APPLICATION NO.	FILING DATE	FIRST NAMED INVENTOR	ATTORNEY DOCKET NO.	CONFIRMATION NO.
09/973,133	10/09/2001	Shunpei Yamazaki	SEL 281	4744
7590 08/01/2005				
COOK, ALEX, McFARRON, MANZO CUMMINGS & MEHLER, LTD SUITE 2850 200 WEST ADAMS STREET CHICAGO, IL 60606		EXAMINER KEBEDE, BROOK		
		ART UNIT 2823		PAPER NUMBER

Office Action Summary	Application No. 09/973,133	Applicant(s) YAMAZAKI ET AL.	
	Examiner Brook Kebede	Art Unit 2823

DETAILED ACTION***Claim Rejections - 35 USC § 112***

As shown in Fig. 2A of the instant application and depicted herein below, the reverse bias is a negative bias voltage.

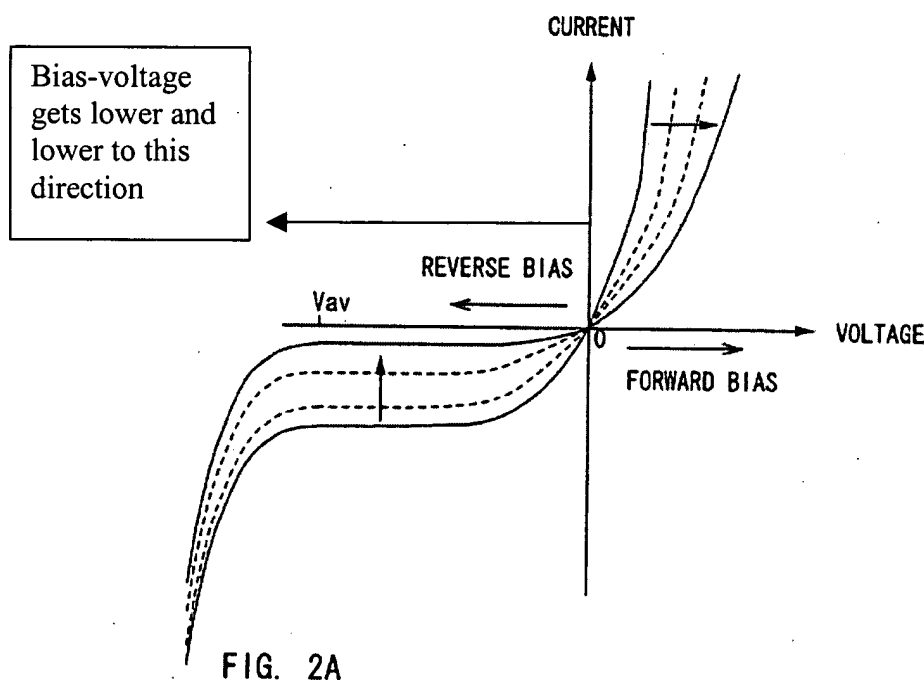
Claim 9 recites the limitation "wherein magnitude of the second reverse bias voltage is higher than magnitude of the first reverse bias voltage" in lines 8-9. However, the recited limitation is not clear in its meaning and scope for the following reasons:

However, it is not clearly specified in the claim that which magnitude of the first and the second reverse bias voltages are claimed. As shown in Fig. 2A the reverse bias voltage gets further lower and lower when further out the left of the abscissa. However, it is not clear at what point the first and the second bias voltages are taken. Hence, the claim lacks clarity in its meaning and scope. Therefore, the claim is indefinite for failing to particularly point out and distinctly claim the subject matter which applicant regards as the invention.
